RELABELLING OF OUTPUT TERMINALS Kit 179

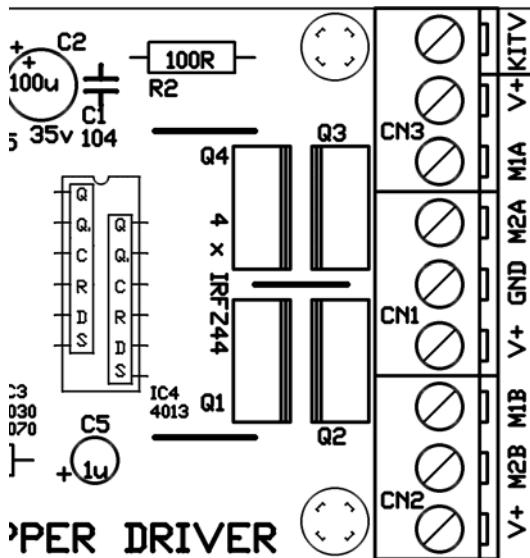
Please note we made some errors on the labelling of the output terminals on this PCB.

The correct labelling is shown to the left.
